Agenda Item #: 2 SUB-002454-2023

Pinehurst Subdivision Delany's Addition to Spring Hill, Resubdivision of Block 8 and Portion of Block 9

APPLICATION NUMBER 2 DATE April 20, 2023

DETAIL SITE PLAN

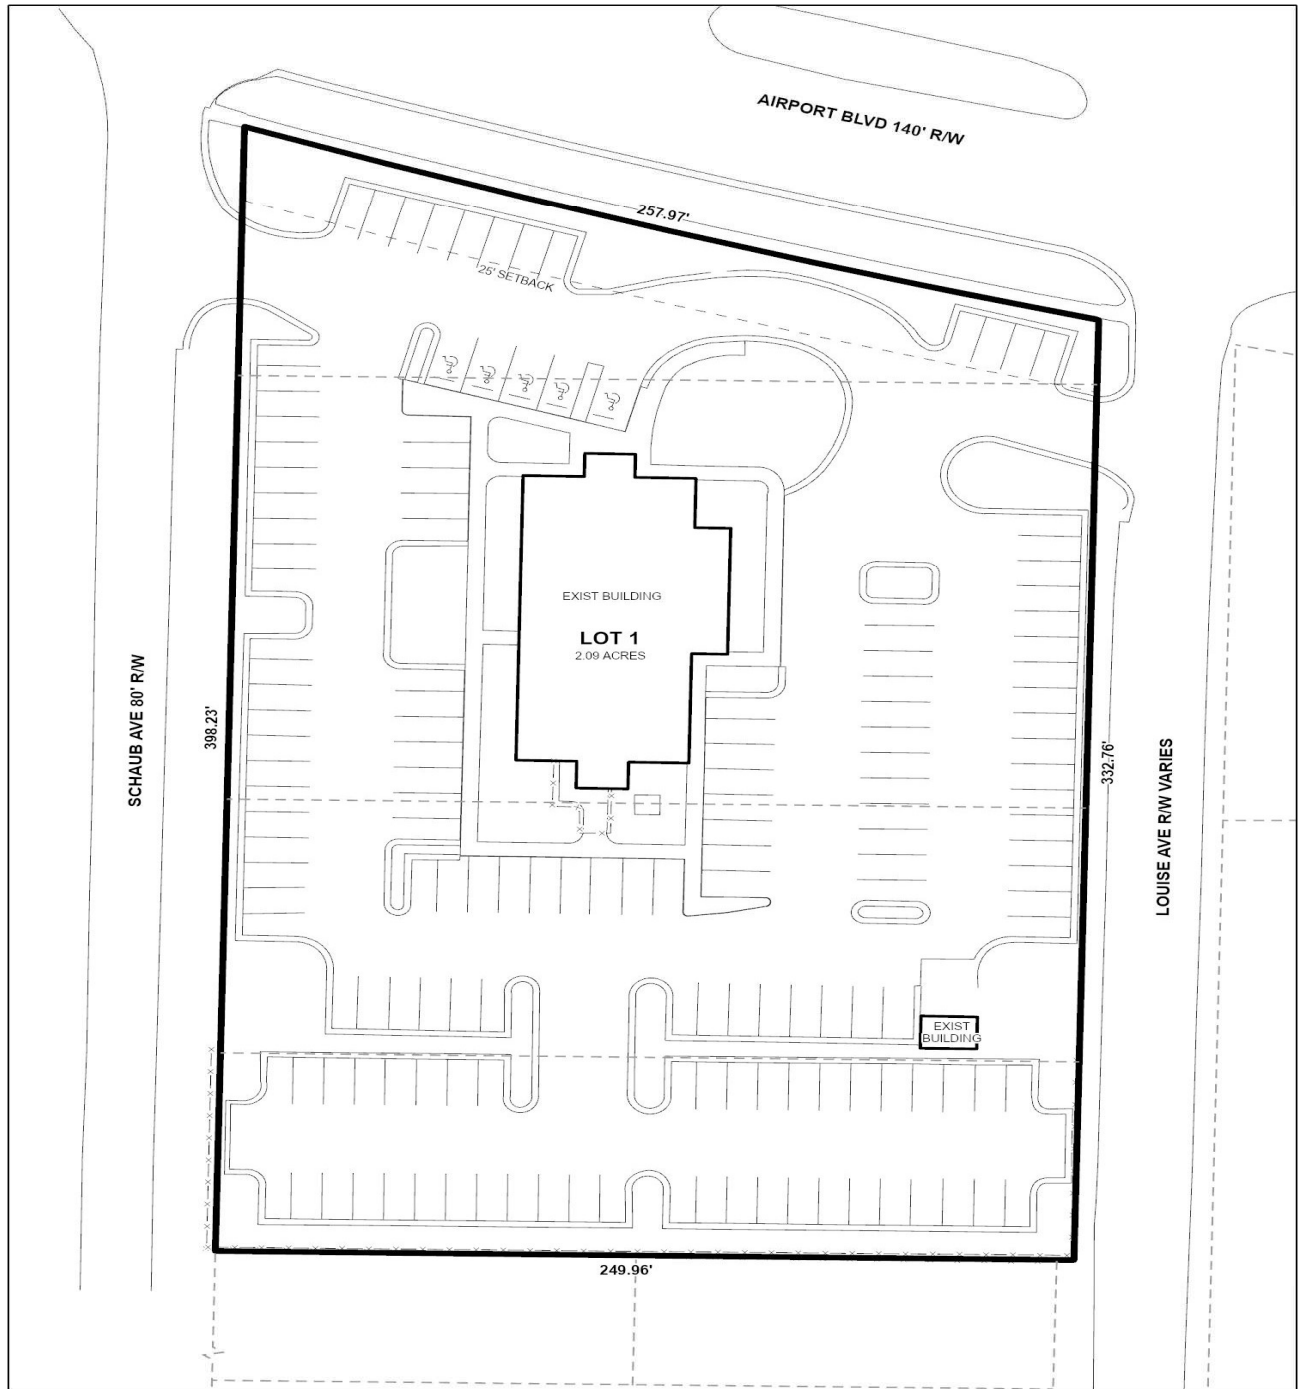
- B. Add legible street names to the vicinity map.
- C. Dedicate the corner radius (25' minimum or as approved by the City Engineer and Traffic Engineer) at the northeast corner and northwest corner of LOT 1 to the City of Mobile, and list the amount of dedicated acreage (sf and ac).

Based on Section 3.E of the Subdivision Regulations, the proposed subdivision cannot be classified as a minor subdivision, due to corner radii being required, if approved.

The proposed site has frontage both on Airport Boulevard, a principal arterial street requiring a 100-foot right-of-way, and Louise and Schaub Avenues, minor streets with no curb and gutter, thus requiring a 60-foot right-of-way. The preliminary plat illustrates compliant rights-of-way along Airport Boulevard and Schaub Avenue. The preliminary plat illustrates a 50-foot right-of-way along Louise Avenue which has existed in its current configuration since 1909, therefore, a waiver of Section 6.B.9. of the Subdivision Regulations may be appropriate.

Per Section 6.B.12. of the Subdivision Regulations, dedication of corner radii should be required, if approved.

The lot exceeds the minimum size requirements of the Subdivision Regulations, and the lot size is provided in acres. If approved, the lot size should be provided in square footage and acres, adjustment for dedication.

The preliminary plat submitted indicates an existing 25-foot minimum building setback line along Airport Boulevard, which meets the minimum building setback required by Section 6.C.8. of the Subdivision Regulations. If approved, the setback should be depicted along all street frontages, adjustment for dedication.

1. Retention of all right-of-way widths as depicted on the preliminary plat;
2. Dedication of corner radii per Section 6.B.12. of the Subdivision Regulations;
3. Retention of the lot sizes in both square feet and acres, or the furnishing of a table on the Final Plat providing the same information;
4. Depiction of 25' setback along all rights-of-way;
5. Waiver of Section 6.B.9. of the Subdivision Regulations for Louise Avenue;
6. Compliance with all Engineering comments noted in this staff report;
7. Placement of a note on the Final Plat stating all Traffic Engineering comments noted in this staff report;
8. Compliance with all Urban Forestry comments noted in this staff report; and,
9. Compliance with all Fire Department comments noted in this staff report.
